M E M O

To: Mike Zimmerman, Everglades National Park

Date: November 30, 2000

Subject: C111 - GRR Supplement

S331 Phosphorus Data

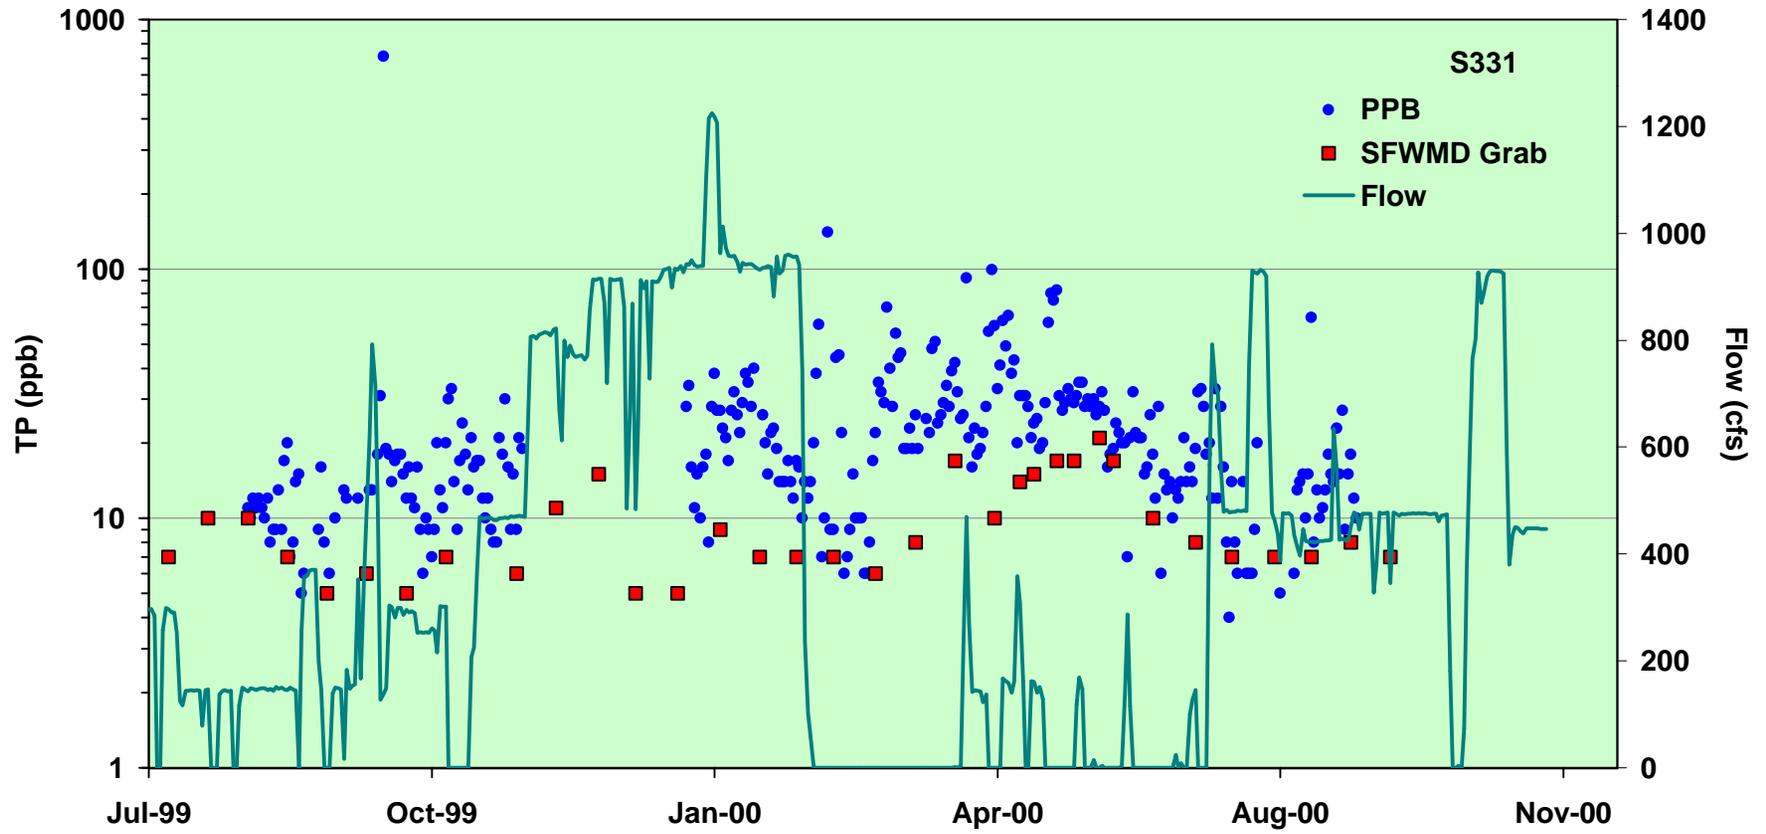
Evaluation of potential water quality problems is hindered by discrepancies in the phosphorus data. These discrepancies are obvious in the attached graphs of data from S331, S332D, and S332. Processes to resolve these problems are reportedly underway. Despite considerable efforts under the Everglades Round Robin program, data incompatibility across labs continues to be a significant problem in attempting to integrate monitoring and research results, particularly in these low concentration ranges. To minimize these problems in the future, I recommend that all monitoring be conducted by SFWMD under an appropriate cost-sharing agreement. Since buffer cell sizes are determined by land constraints (vs. an engineering calculation based upon loads), data uncertainties do not seem to be on the critical path of this project at this point. Resolution of these matters should be a TOC priority.
